I am currently reviewing the proposed modifications to the Integra Underground (PA 08_0101 MOD 7) and Mount Owen (SSD 5850 MOD 1) mines and wish to seek some clarification on an inconsistency in your application information.

The Department has furthered its assessment of the IUG/MO water pipeline proposal and requires some further information to complete its consideration of the proposals.

I am currently involved in the team reviewing the proposed Integra to Mount Owen Water Pipeline modifications.

From: Chloe.Piggford@glencore.com.au
Sent: Thursday, 10 August 2017 2:52 PM
To: Matthew Sprott
Subject: RE: IUG/MO Modifications RFAI
Attachments: HB1651 F1 Vegetation Communities_Planting Areas.pdf

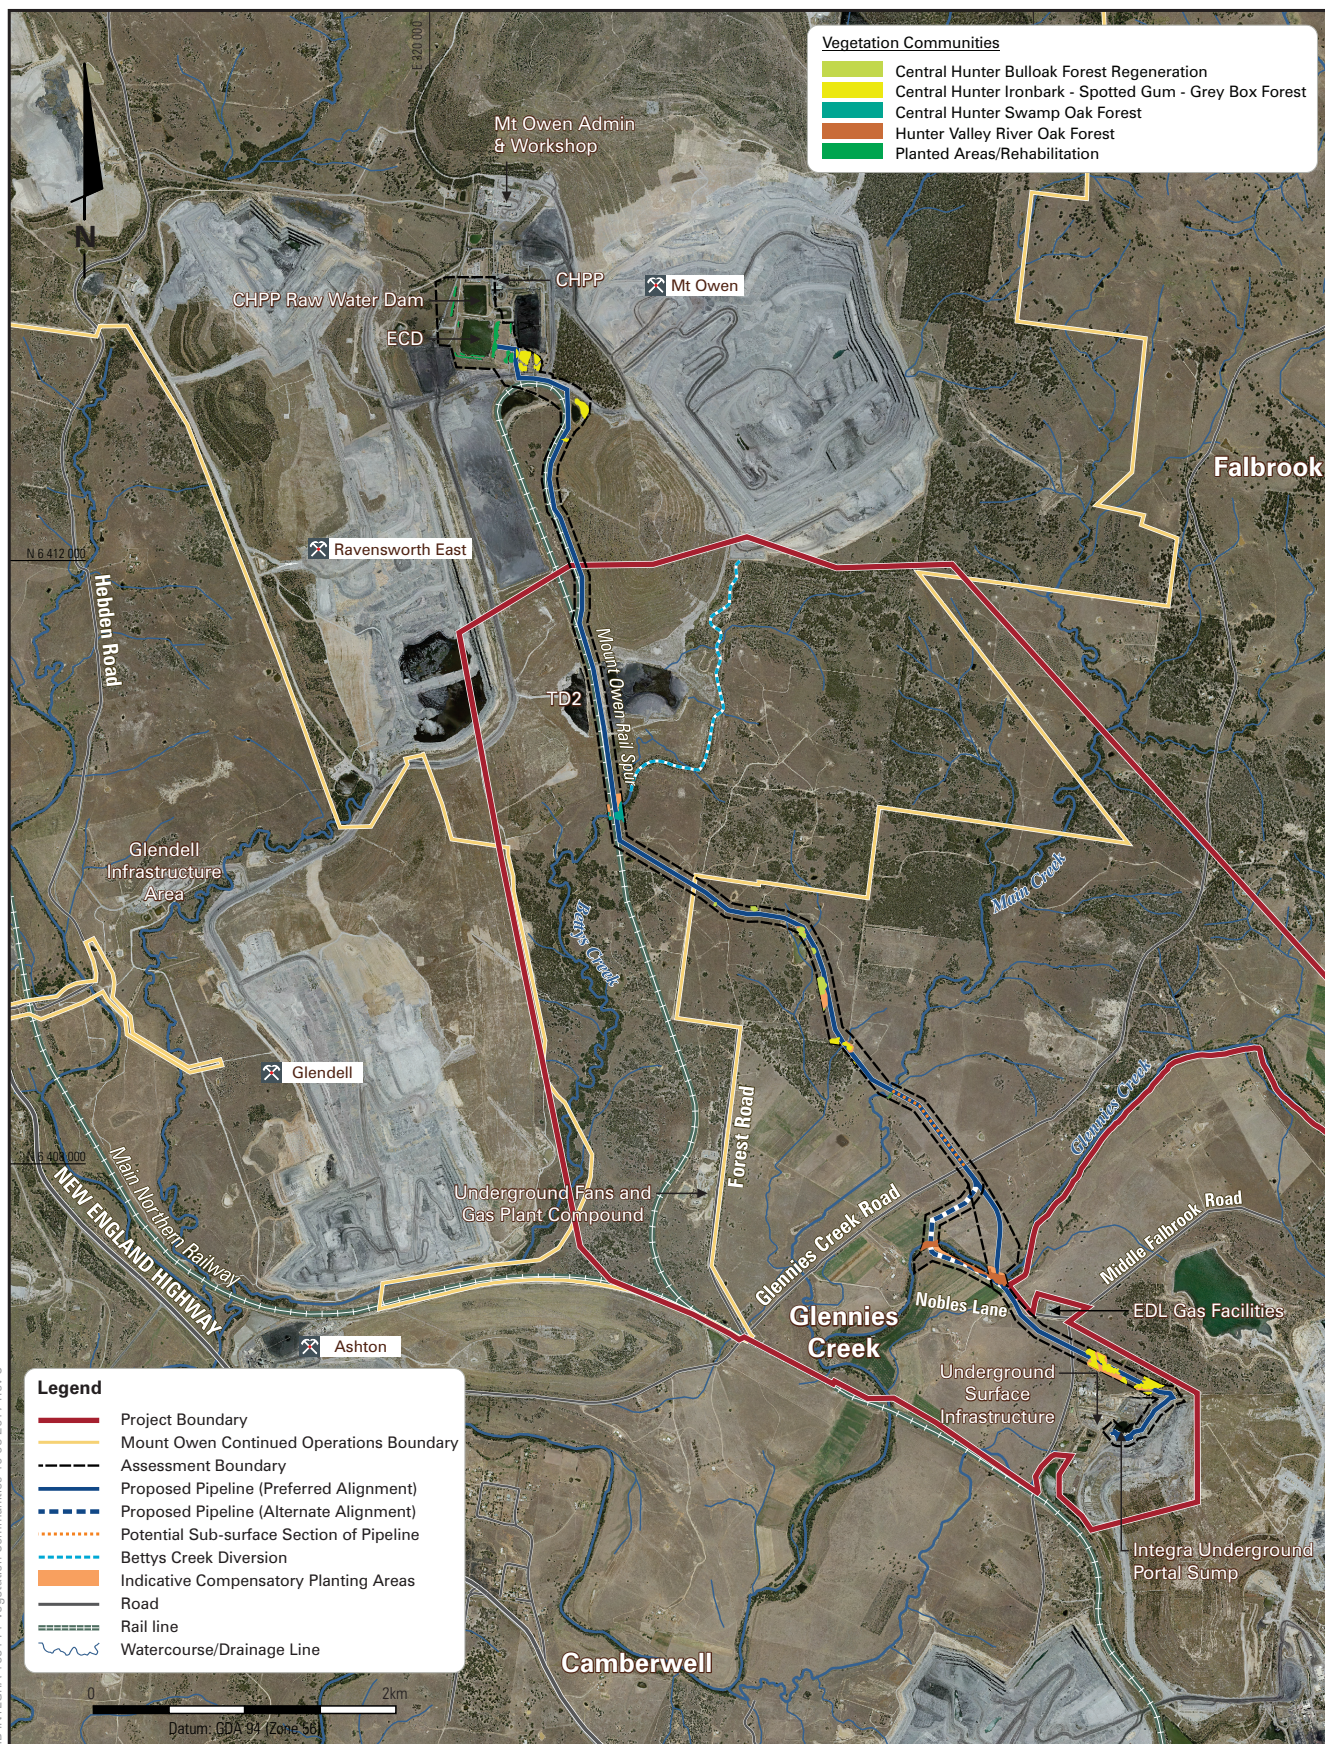
The Department is yet to be satisfied that the biodiversity impacts of the proposal have been adequately addressed and considers that further information is required to address OEH's outstanding concerns regarding the adequacy of biodiversity offsets. The Department is liaising with OEH to determine the quantum of offsets required for the proposal and confirm appropriate approaches to managing the potential for flood impacts on private property.

The Department is currently considering requirements for additional biodiversity offset or compensation measures, including the potential for these to be provided through an increase in the area of rehabilitation EEC woodland under the Mount Owen consent. The Department will also be seeking to reflect the avoidance, mitigation and management measures detailed in the EA in its recommendations and strengthen these measures in line with recent management and compensatory planting measures imposed under consents for recent modifications at the Mount Owen Complex.

Prior to seeking Glencore's feedback on any proposed draft conditions, the Department is requesting any further feedback from Glencore on OEH's submission and any alternative proposals to account for the biodiversity impacts of the project.

In addition to the above mentioned management and mitigation commitments and in response to OEH submission in relation to offsetting requirements, the Proponents proposes the following additional compensatory planting measures consistent with recent modifications at the Mount Owen Complex.

As the Proponent is avoiding the removal of trees with a trunk diameter of 10 cm or greater, where removal of woody vegetation is unavoidable, the Proponents proposes to plant and maintain, until established (greater than 2 m in height) five trees of the same species for every tree conforming to the Central Hunter Ironbark – Spotted Gum – Grey Box Forest, Hunter Valley River Oak, Central Hunter Swamp Oak and Central Hunter Bulloak vegetation communities which is removed through the activities associated with the construction of the water pipeline. For example, for each Hunter Valley River Oak tree removed as a result of the construction of the water pipeline, five Hunter Valley River Oak trees will be planted and maintained, until established. We propose that this requirement is included in the Integra Underground Project Approval.

These plantings will occur within, or in the vicinity of, the Assessment Boundary with the aim of linking to the existing patches of these vegetation communities adjacent to the proposed pipeline alignment.

Indicative planting areas are shown in the attached figure. Actual planting areas will be ground-truthed and undertaken by suitably qualified personnel to provide for the highest chance of success. These plantings will also comply with the general principles for the revegetation works as outlined in Integra Underground's Biodiversity Management Plan. Section 3.3 of the Integra Underground Biodiversity Management Plan (approved by DPE in April 2017) states:
